BEDFORD II LANDFILL COVER

August 9, 2011

**Re: Construction Storm Water Inspection at Bedford II Landfill Cover
Franklin County
Permit Number: 4GC03047*AG**

Figure 1: Sediment laden waters leaving property, skimmer also requires maintenance.

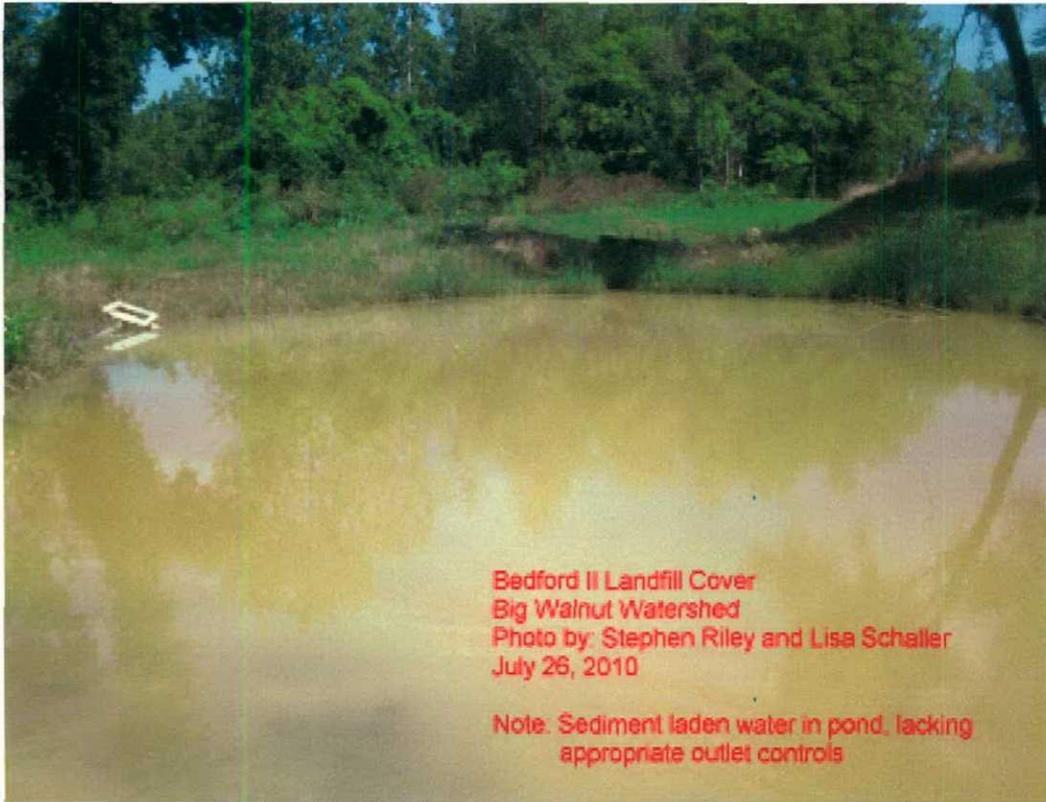
- The temporary skimmer has been compromised. Corrective measures must be conducted to ensure the intended function of the skimmer discharge. The sediment pond will require cleaning as it appears that fifty percent of the capacity of the pond has been eliminated due to accumulated sediments from recent rain events.

Note: Sediment laden water in pond, lacking
appropriate outlet controls
